# Access Compliance Report

## Public Rights-of-Way

### (Curb Ramps)

Intersection ID: 10015635	Main Street: HARRIS_CORNERS_PY	Cross Street: N/A	Location: S
ADA ID: 8203A1C7973E	Ramp Type: BlendTrans2	Initial Pass/Fail: Fail	Overall Compliance: No
		Severity Score: 10

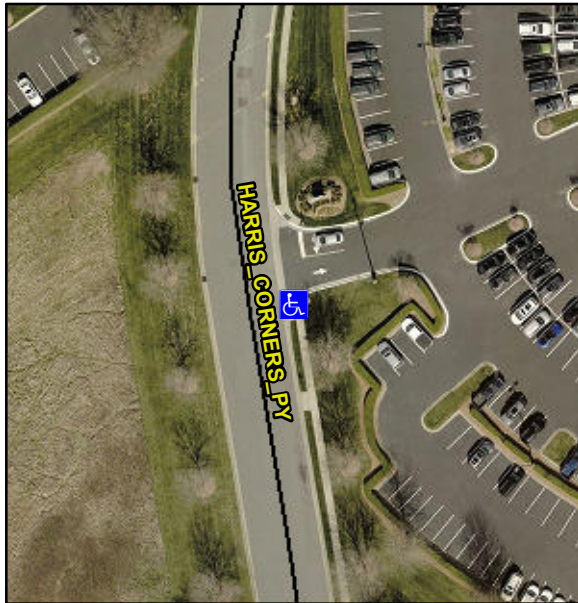
**R304.5.1, R304.5.3**

Compliance	Description	Data	Compliance	Description	Data
N/A	Ramp Length (in)	<b>60.0</b>	Yes	BlendTrans Slope (%)	<b>3.5</b>
No	Ramp Width (in)	<b>42.0</b>	No	BlendTrans XSlope (%)	<b>2.4</b>
N/A	Flare Type LT	<b>N/A</b>	N/A	Flare Type RT	<b>N/A</b>
N/A	Flare Slope LT (%)	<b>N/A</b>	N/A	Flare Slope RT (%)	<b>N/A</b>
N/A	Flare Traversable LT?	<b>N/A</b>	N/A	Flare Traversable RT?	<b>N/A</b>
N/A	Landing Length (in)	<b>N/A</b>	N/A	DWS Provided?	<b>N/A</b>
N/A	Landing Width (in)	<b>N/A</b>	N/A	DWS Contrast?	<b>N/A</b>
N/A	Landing Slope (%)	<b>N/A</b>	N/A	DWS Length (in)	<b>N/A</b>
N/A	Landing X Slope (%)	<b>N/A</b>	N/A	DWS Full Width?	<b>N/A</b>
N/A	Landing Curb? (Y/N)	<b>N/A</b>	N/A	DWS Offset (in)	<b>N/A</b>
N/A	Shared Landing?	<b>N/A</b>			
N/A	Gutter Ponding?	<b>N/A</b>	N/A	Gutter Slope (%)	<b>N/A</b>
N/A	Gutter Lip Ht (in)	<b>N/A</b>	N/A	Gutter X Slope (%)	<b>N/A</b>
N/A	Painted X Walk1?	<b>No</b>	N/A	Painted X Walk2?	<b>No</b>

**Remove & Replace Curb Ramp With Two New Directional Ramps or Equivalent.**
